UK Healthcare Richmond Improvements

ADDENDUM # 3

Addendum #03

Client	University of Kentucky Healthcare	Date	2025-03-21
Project	UK Richmon MOB	UK Project #	12566, 12567, 12568, 12569
	UK - CCK-1256x-1-25	Champlin Project #	514-7484

FIRST FLOOR - NEW WORK LIGHTING PLAN
 SCALE: 1/8" = 1'-0"
 0 4 8 16 24

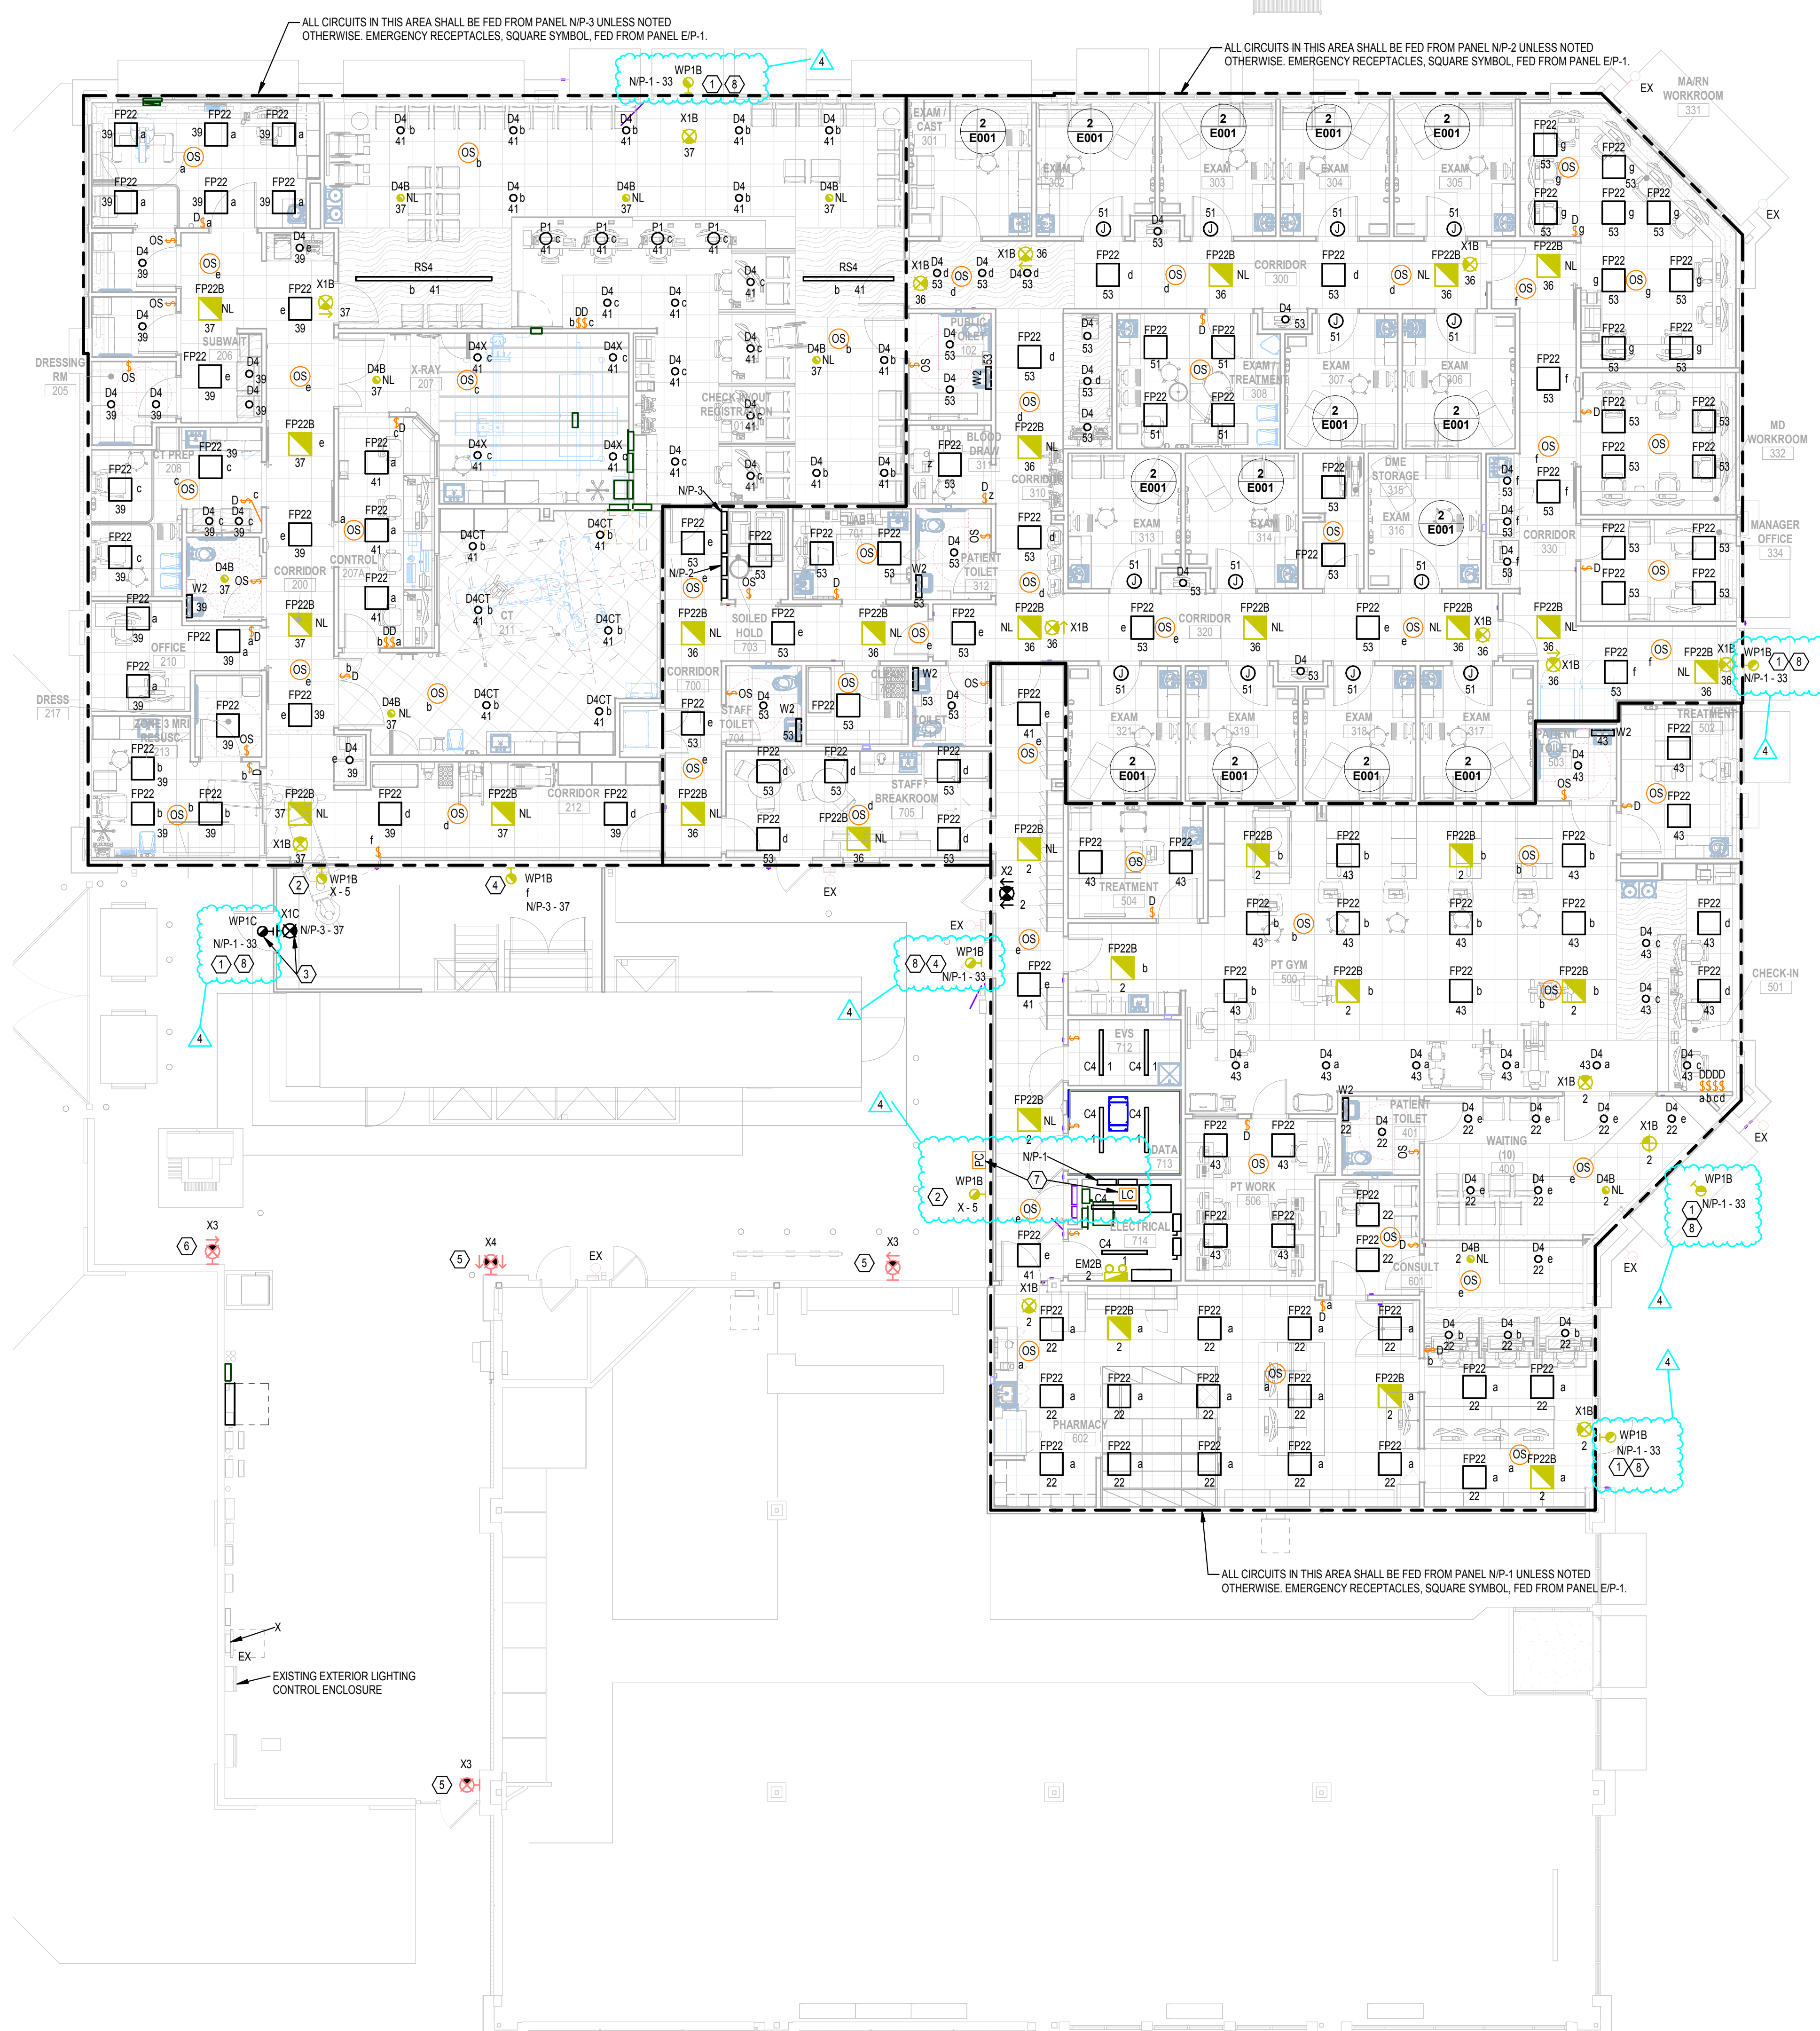
1. *Exterior lighting control clarified.*

1 FIRST FLOOR - NEW WORK POWER PLAN
SCALE: 1/8" = 1'-0"

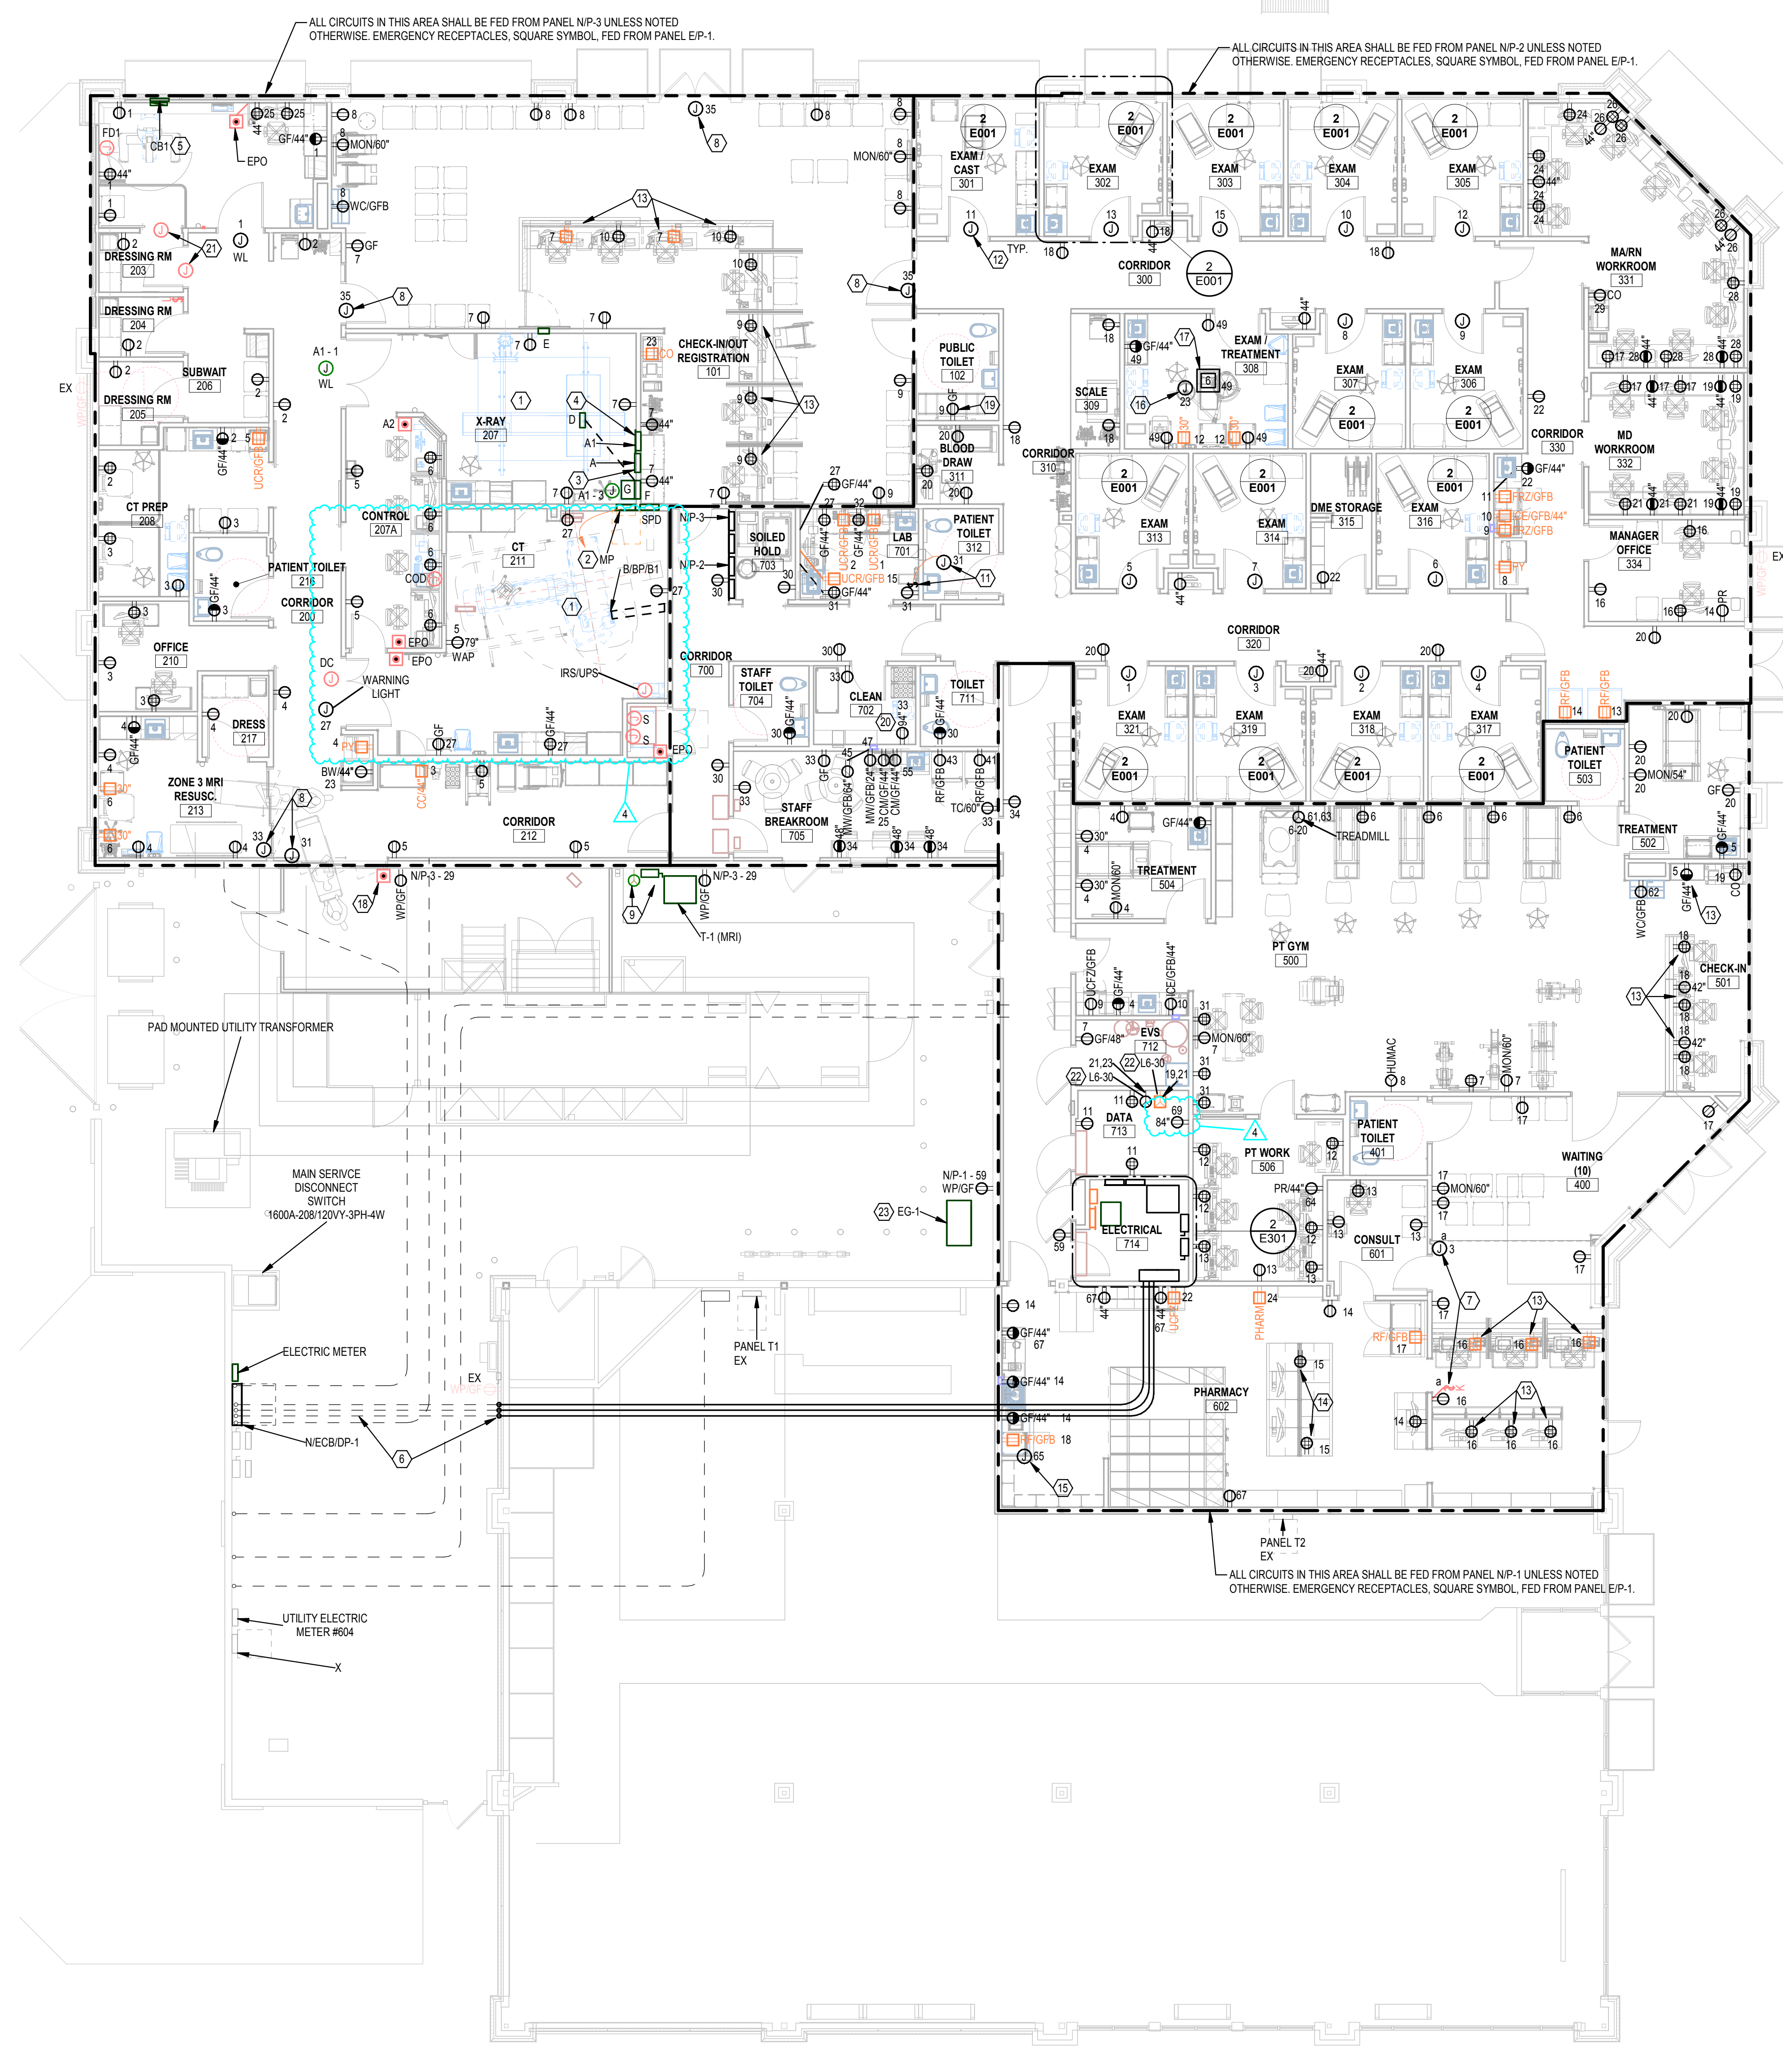
1. *CT room revised and circuit clarified in data room.*
